## KY-040 Rotary Encoder breakout board part

I was searching for a Fritzing part for a KY-040 rotary encoder. They usually come on a breakout board. But I wasn't able to find one, or rather a working one. Interestingly enough, one does find plenty Fritzing sketch images with one such part, but nowhere an actual part.

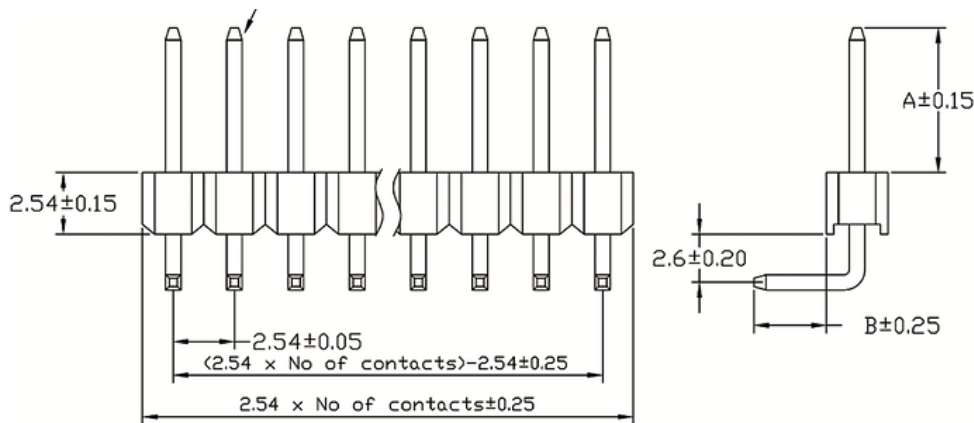
The schematic graphic is bigger than it needs to be. Pins should be 0.1 in long, and a series of them (ST, DT, CLK) should be 0.1 in apart. The pins should align (both horizontal and vertical) to the 0.1 inch grid. Your +

and GND pins are not a multiple of 0.1 inch from ends of the other 3 pins, so some pins do not align to the grid.

From what I read, I got the impression that for all three views the part dimensions should mirror the real dimensions. So would you say that this is not necessary for the schematic SVG, and that the schematic part should just be large enough to host all the pins and necessary information?

I used the real dimensions and then wanted to put the top and bottom pins in the middle, so it ends up not being a multiple of 0.1 inch from the other three pins. From how I understand your comment, I should rather have the whole part adhere to the 0.1 inch grid in the schematic SVG, as it will also move on such a grid in Fritzing's schematic view. Hmm, but the pin's length is 0.1 inch, isn't it? I thought I had that right.

Yes. Schematic is a functional/logical representation. It does not need to match the physical part. PCB view has to match the physical part, for it to fit on the board. Breadboard also need to match close to physical, but is not always the same as PCB. Sometimes breadboard is a breakout board, but the PCB is a bare component. Or breadboard is a DIP package/part, and PCB is SMD.

The + and GND pins were 0.1 inch, but the others seemed off a bit.
